To: **South Tyneside Council**  
From: **Iceni Projects Ltd (Transportation)**  
Date: **12<sup>th</sup> February 2016**  
Title: **ST/0955/15/FUL - Former Be Modern Premises, Western Approach, South Shields**

**b. Response to STC Comments**

**A4. COACH TRACKING**

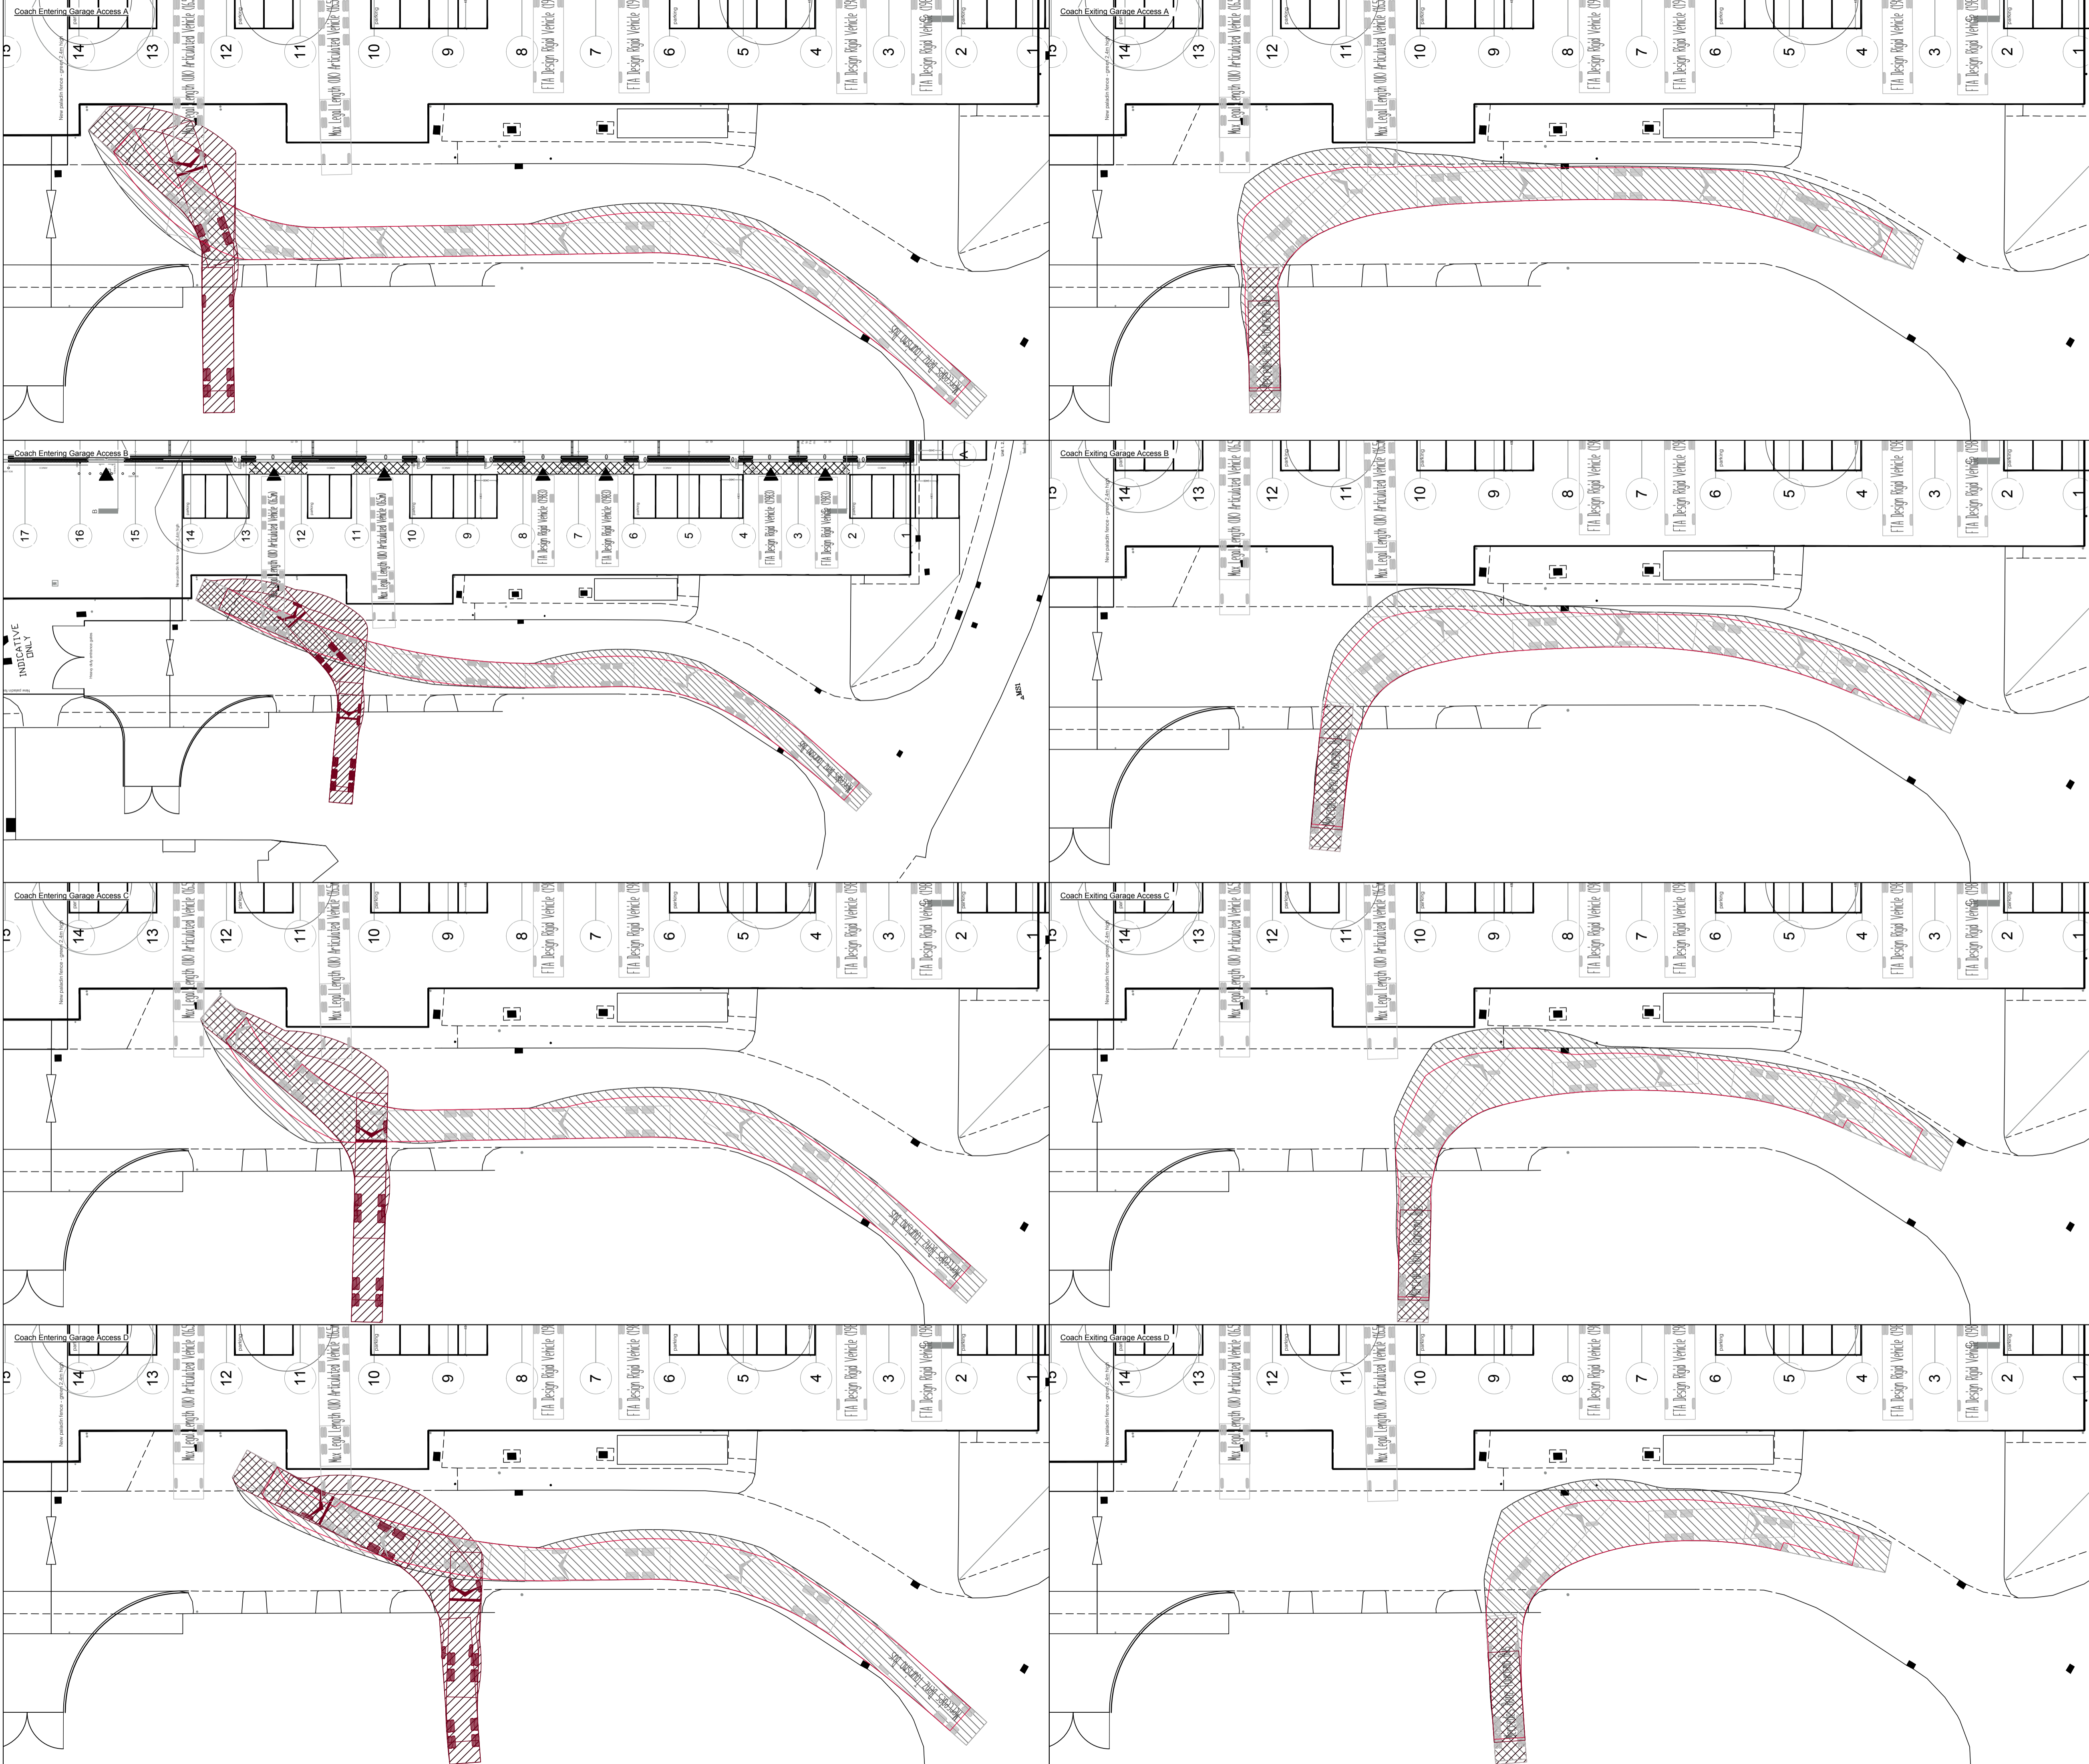
33. *It needs to be taken into consideration that Wilson Street is an adopted highway and therefore open to public use. Therefore the safety of the proposed manoeuvres needs to be fully considered as well as the existing adjacent business and any future development to the north west of the site where buildings have been demolished.*

38. In order to consider the impact of the development on the existing coach company located on the western side of Wilson Street a swept path analysis has been undertaken based on 12m coaches entering and exiting the coach company site via their existing accesses assuming a delivery vehicle is parked in each of the loading bays at the proposed development. A drawing showing this is included at Appendix A4. The tracking shows that if a coach attempts to enter or exit the garages while a 16.5m articulated lorry is servicing the proposed development it will not be possible for a coach to manoeuvre into or out of the garages in a simple manoeuvre. It is likely that this could be achieved by undertaking more manoeuvres than those shown on the tracking drawing. It should be noted that the likelihood of conflict is extremely low as there will be a maximum of 2 articulated lorries visiting the units per day meaning that for the rest of the day the manoeuvre will not be impeded.

39. It should also be noted that the tracking shows that the coaches cannot manoeuvre in and out of the garages without travelling onto, or at least overhanging, the development site, which will also be the case at present. Furthermore, the building previously located on the site was closer to the road opposite the garages meaning that manoeuvring would have been more difficult. Relocating the building further back will make manoeuvring easier as there will be more space for the coaches to overhang the site when manoeuvring. As such, apart from a very few occasions that an articulated lorry will be servicing the units opposite the garages, access will be no worse than is currently the case and when no vehicles are loading access will actually be improved with the building moving further back from Wilson Street.

## **A5. REFUSE VEHICLE TRACKING**

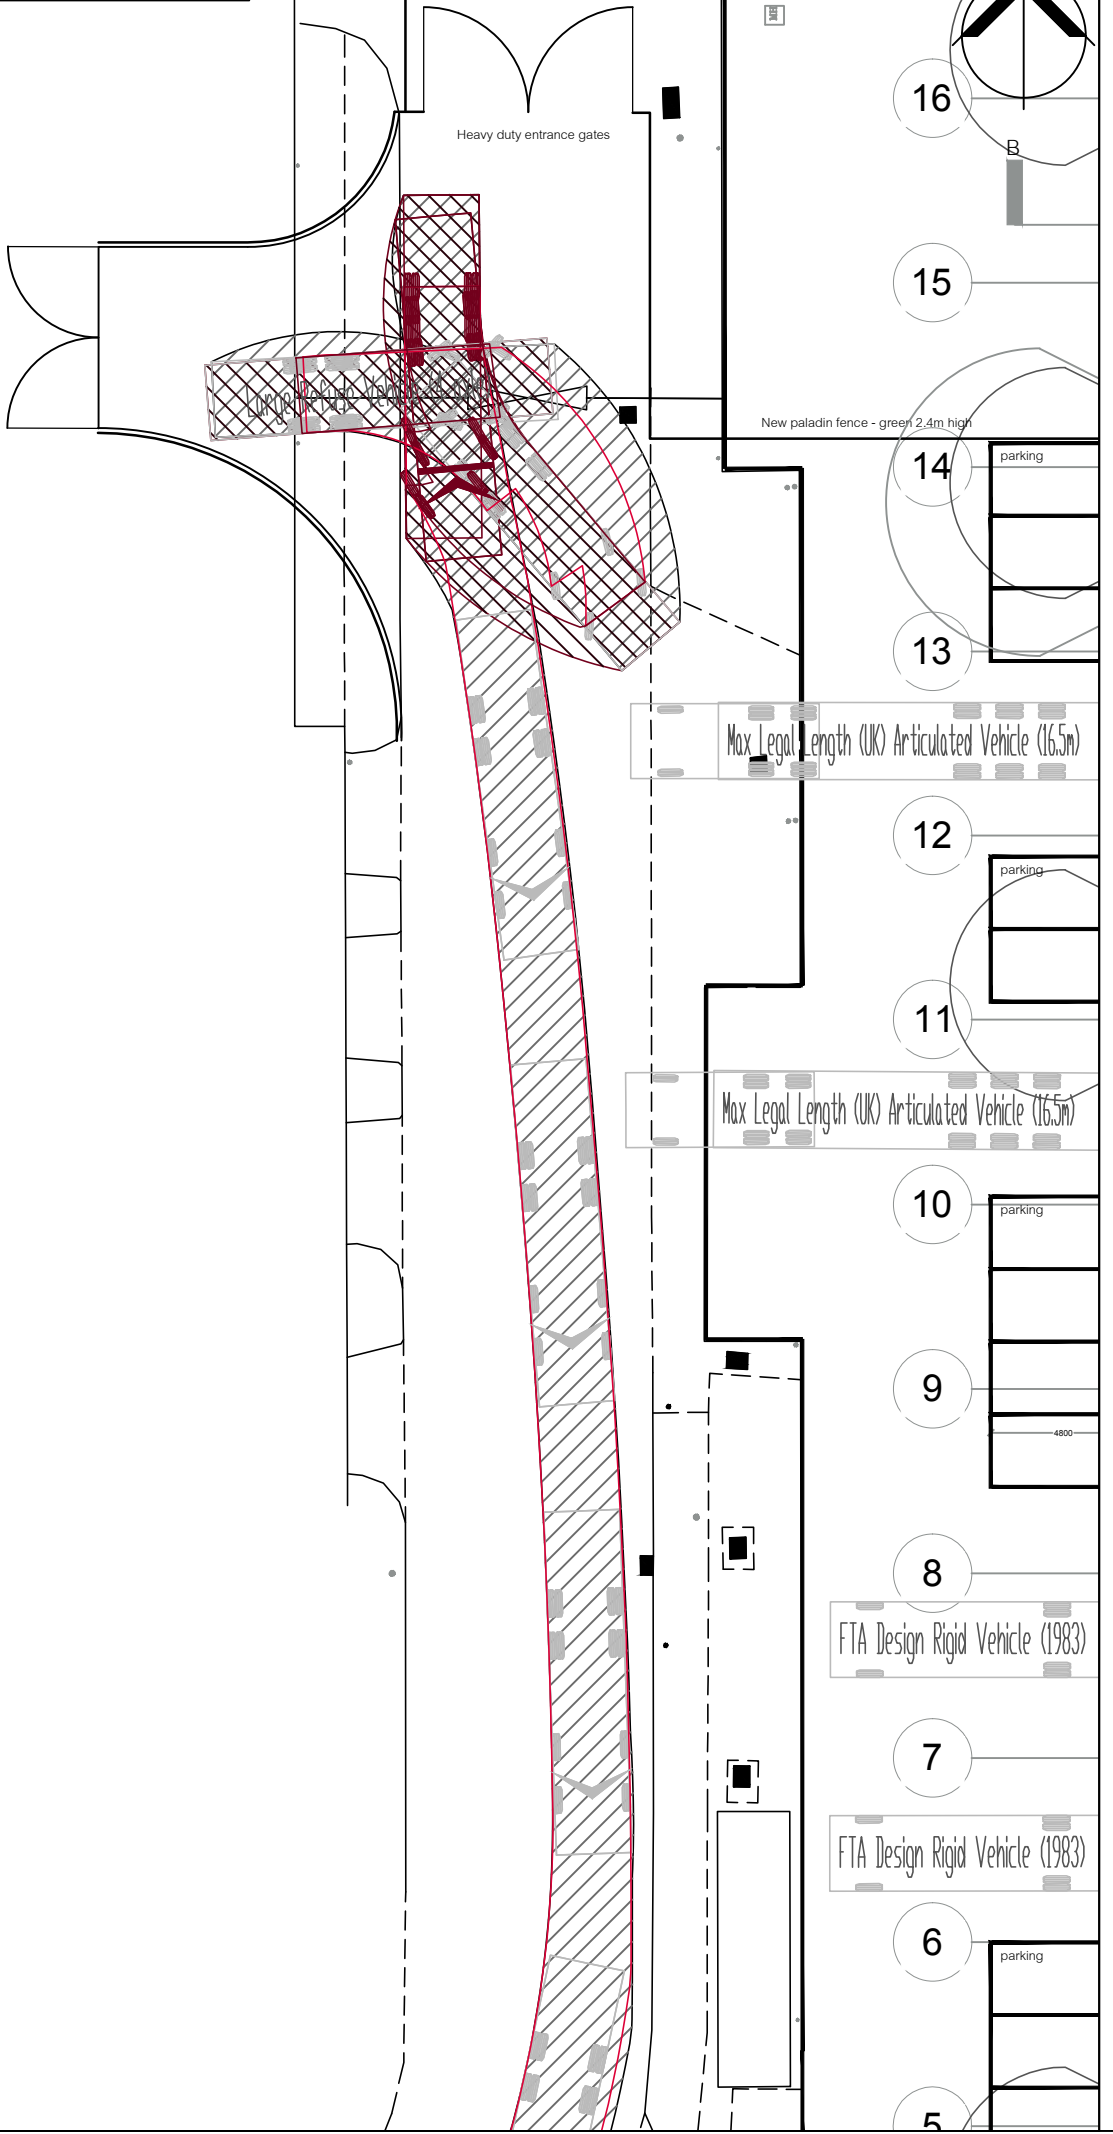
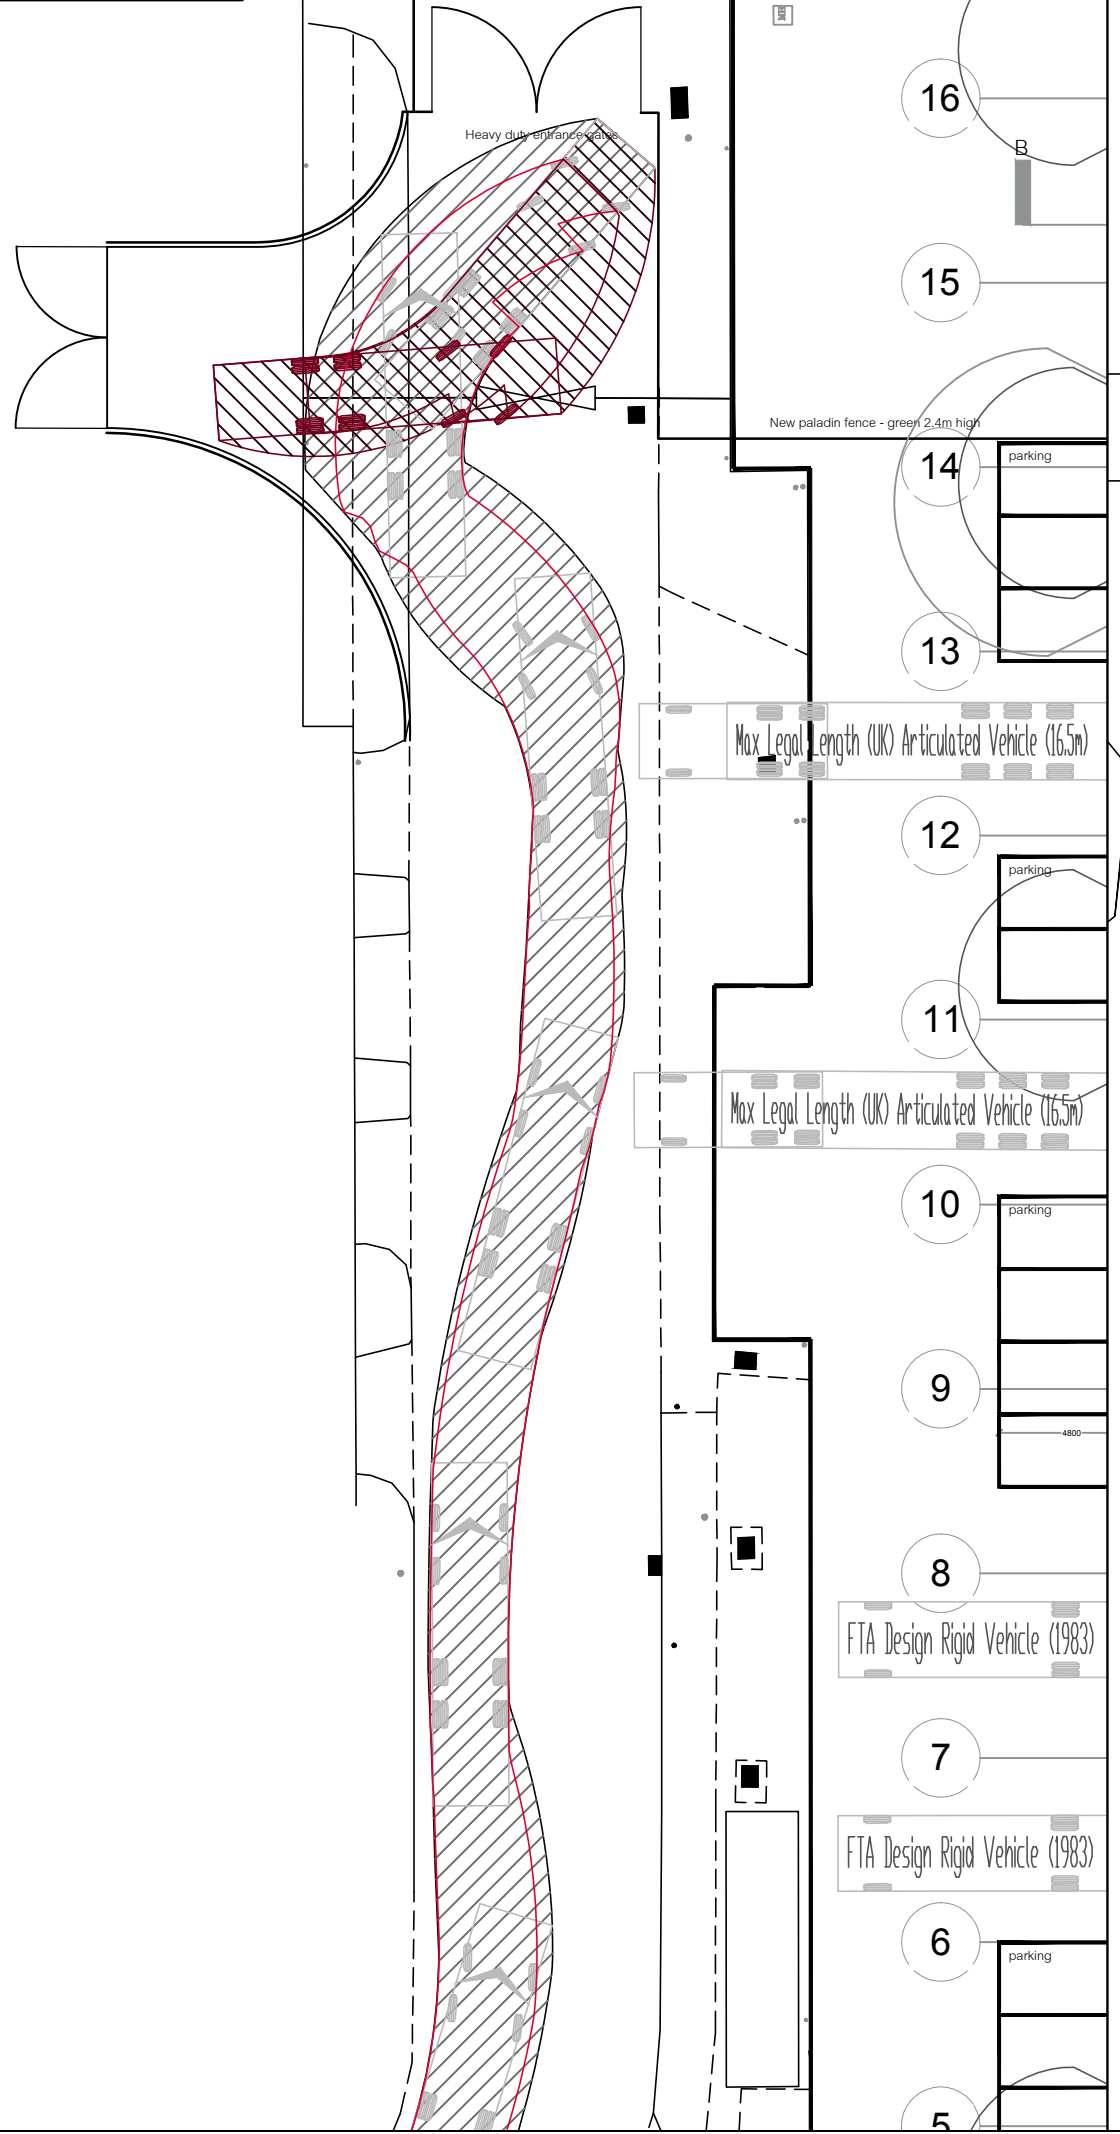
42. *In addition to the above highway comments, I also require further information in respect of waste storage and collection. No bin storage areas have been identified on the proposed plans and the application form has answered 'no' to both questions within section 7. Can you please clarify storage and collection arrangements.*

43. All refuse will be collected by private refuse collectors and waste will be stored within the warehouse of each unit between collections and dragged out by warehouse staff at agreed collection times. Recyclable waste generated by all companies within the Travis Perkins Group is loaded onto their own delivery vehicle and taken back to the warehouse for disposal meaning that only general refuse will be collected by a private company. Further details can be provided post permission if required, however, there is limited additional information that can be provided for the non-Travis Perkins Group occupiers. A tracking drawing is included at Appendix A5 which shows that refuse vehicles can pull off of Wilson Street in front of the staff parking for each unit and run round in this area and the highway to exit Wilson Street in forward gear.
